PRODUCT ADVISORY

Data Sheet Specification Change for Intersil Products ISL78600ANZ and ISL78600ANZ-T

**Refer to:
PA13004**

FIGURE 44. TYPICAL APPLICATIONS CIRCUIT - BATTERY CONNECTION CIRCUITS

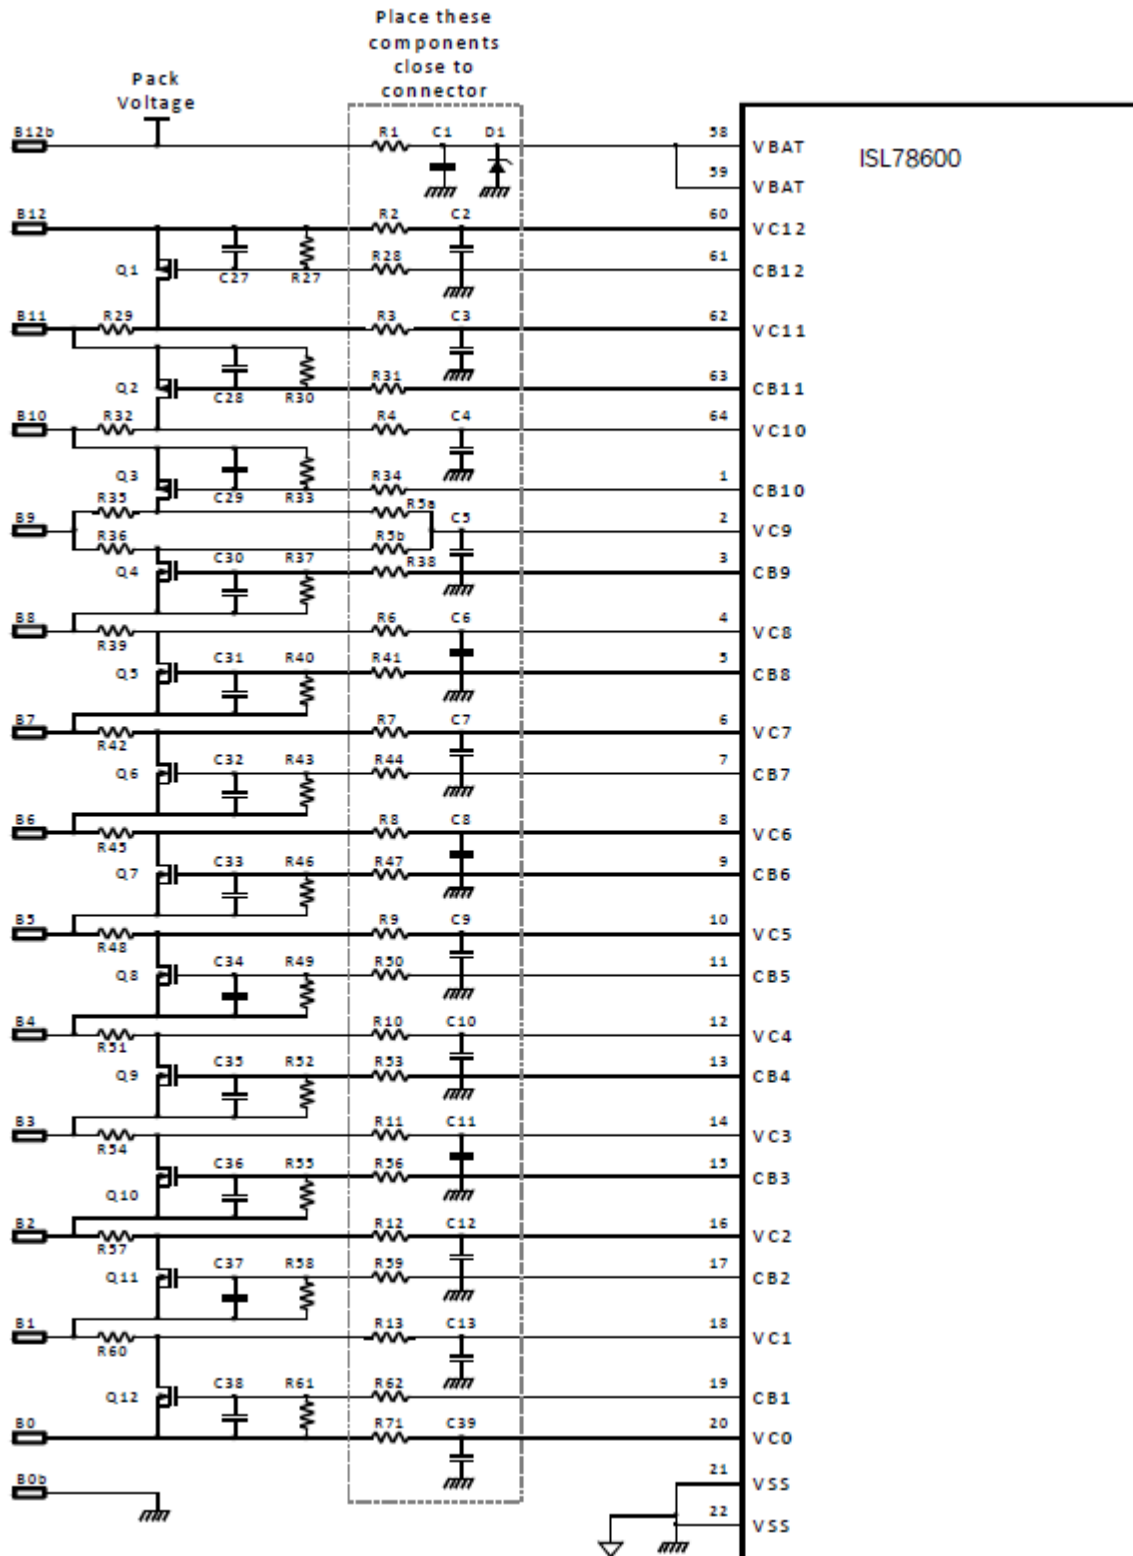
This advisory is to inform you that Intersil has updated the data sheet specification for the ISL78600ANZ and ISL78600ANZ-T products. The updates affect the *Typical Applications Circuits (Figures 45–47)* along with the associated recommended component values in *Table 50* and the component values in *Table 52* for the Daisy Chain Circuit. The resulting Typical Applications Circuits and component tables are included on the following pages. The updated data sheet is available upon request.

- Figure 44 - Typical Application Circuit

FIGURE 45. TYPICAL APPLICATIONS CIRCUIT – NON BATTERY CONNECTIONS, MIDDLE AND TOP DAISY CHAIN DEVICES

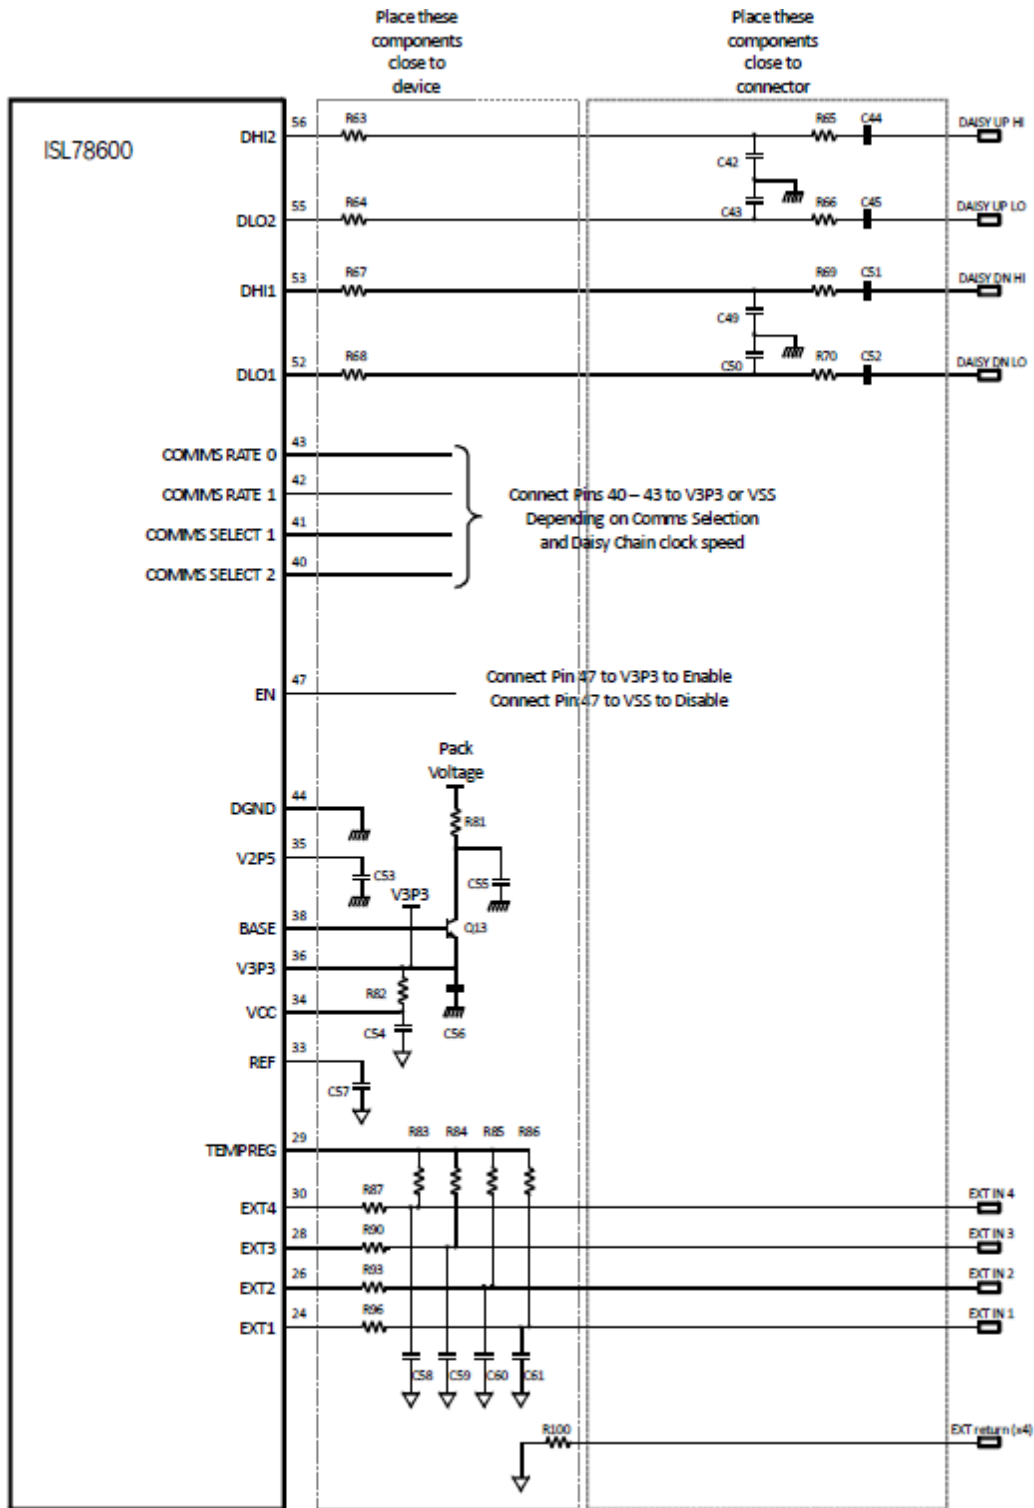
- Figure 45 – Typical Application Circuit

FIGURE 46. TYPICAL APPLICATIONS CIRCUIT – NON BATTERY CONNECTIONS, MASTER DAISY CHAIN DEVICE

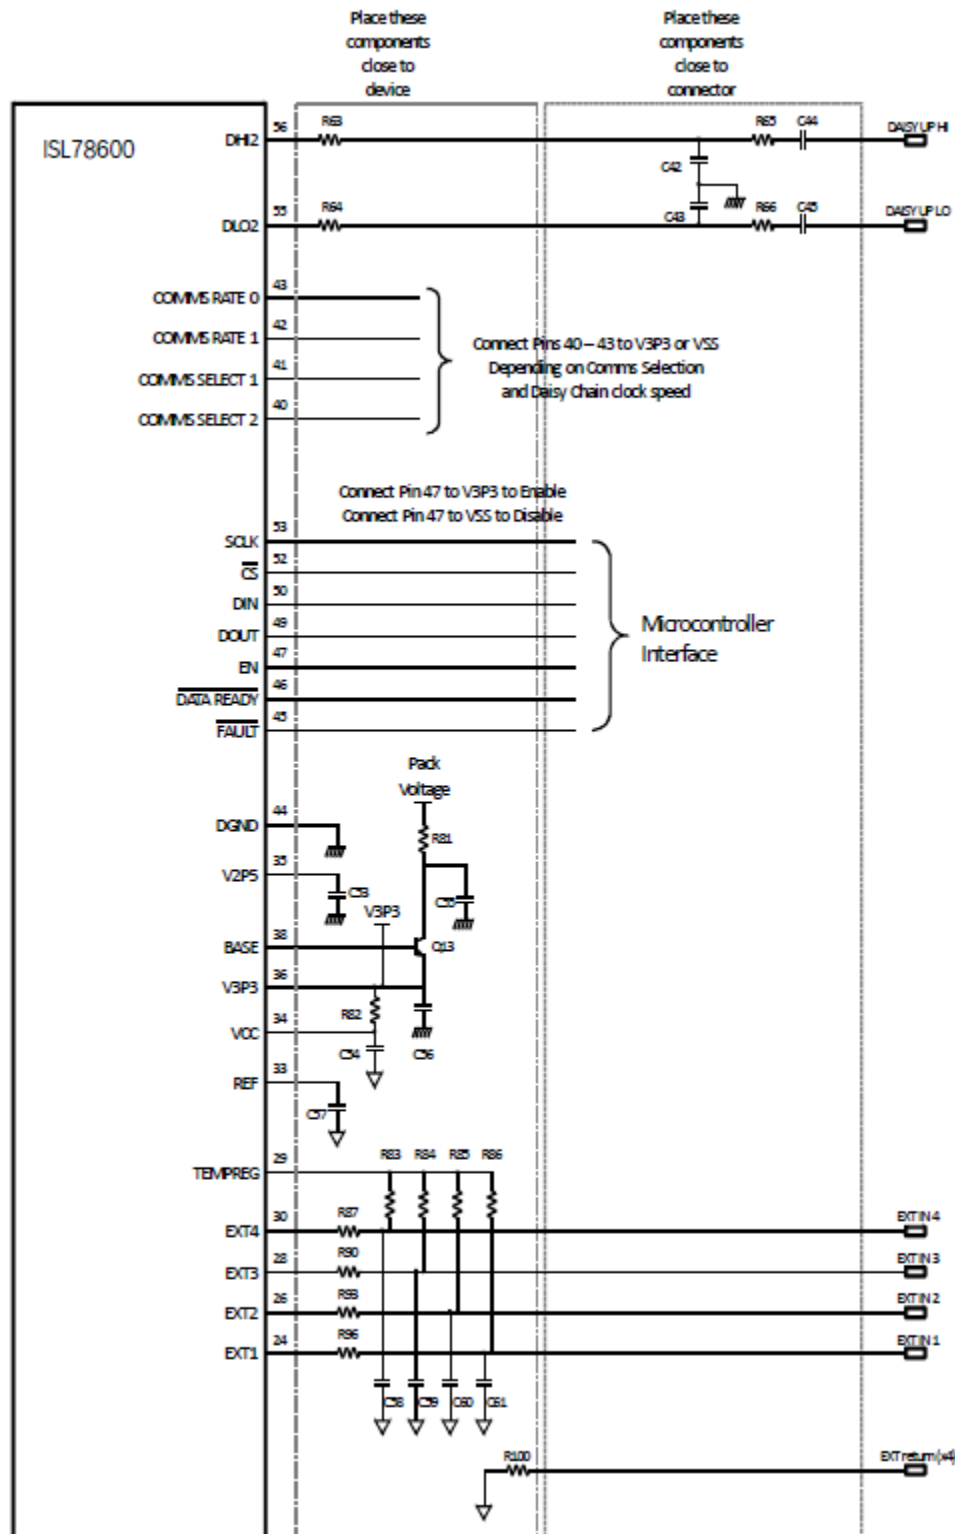
- Figure 46 – Typical Application Circuit

FIGURE 47. TYPICAL APPLICATIONS CIRCUIT - BATTERY CONNECTION CIRCUITS ALTERNATIVE CONFIGURATION

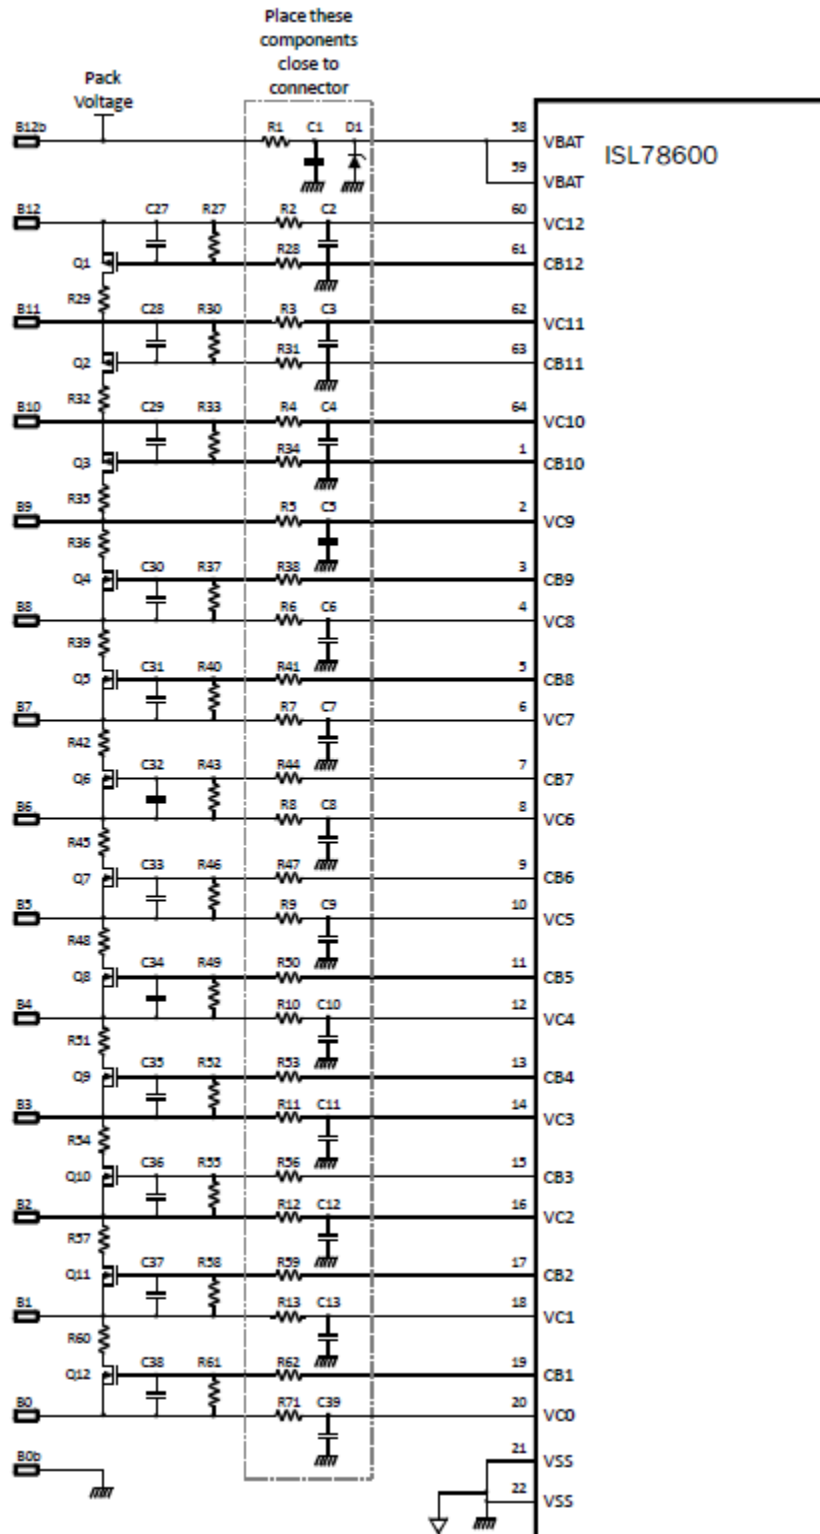
- Figure 47 - Typical Application Circuit
